5. DISCUSSION.

NAVIGATION AND VESSEL INSPECTION CIRCULAR NO. 9-97, CH – 1

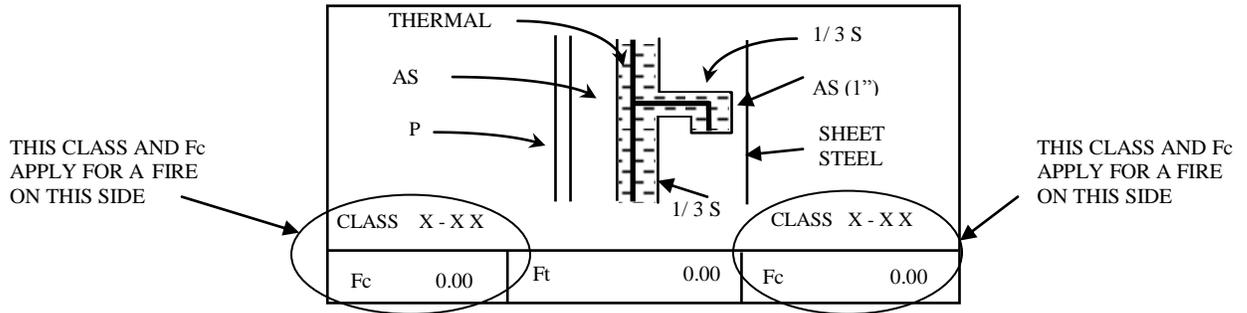
SNAME BULLETIN 2-21  
TYPICAL ALUMINUM INSULATION DETAILS
